Aerospool. Laskusiivekkeiden työntötankojen tarkastus

Koskee: Kaikkia niitä Dynamic WT-9-ultrakevyitä lentokoneita, jotka on varustettu tyypin A laskusiiveketyöntötangoilla..

Subject: Swing bearings and flaps push-rods check

Fig.1 Flaps control system

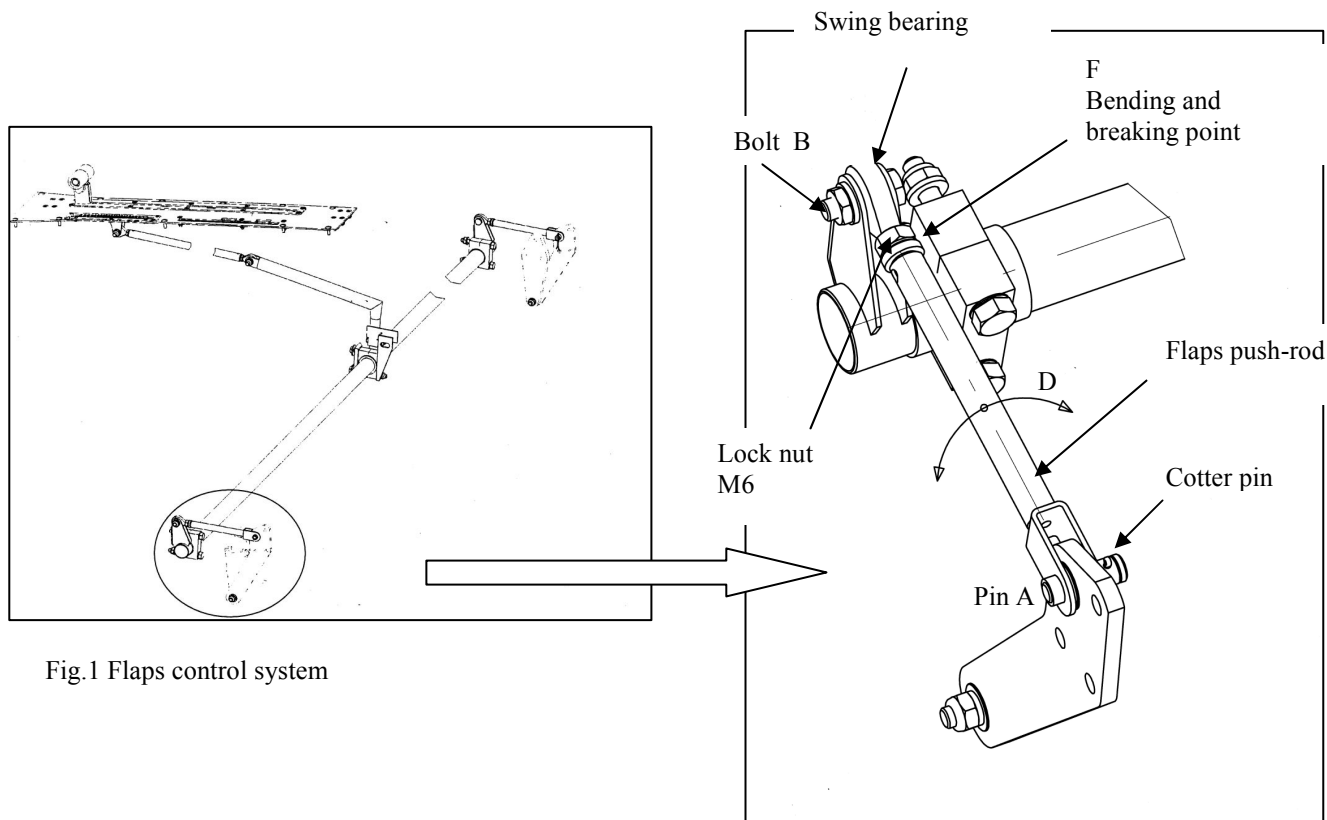
1. Extend the flaps to fully extended position (position flaps 3)
2. Remove the flaps push-rod by following procedure:
 - 2.1 Lock off pin A (remove cotter pin), fig.2
 - 2.2 Put out pin A
 - 2.3 Unscrew the nut of bolt B and put out bolt B
3. Measure and record the total length "d1" on removed flaps push-rod. (see bellow)
Measured value is necessary for reassembly

4. Release the lock nut M6 (fig. 2) and unscrew the swing bearing from flaps push-rod
5. Examine swing bearing (1) and flaps push-rod (2) alignment. Verify if the swing bearing is not bended at point F (see bellow)

1. If the misalignment of flaps push-rod with swing bearing or swing bearing bending was detected in I.5 then both parts, flaps push-rod and swing bearing, have to be changed for new ones
If any doubt related to the condition of flaps push-rod or swing bearing make the exchange for new ones or contact the manufacturer
2. Make installation of new original parts following the procedure described in I.6 - I.11

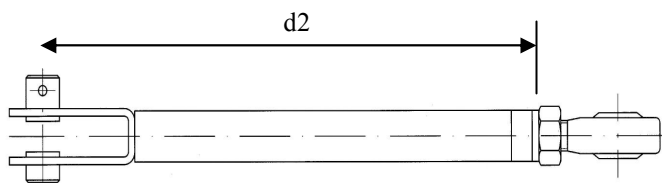
In "Part description box" notice ZBWT9 16A/2012 with length data "d2" for left and right flaps push-rod (data in millimeters)

Material information: swing bearing GAXSW6 (Order No. DYN-604 p30)
flaps push-rod DYN-604-16 (Order No. DYN-604 p7)
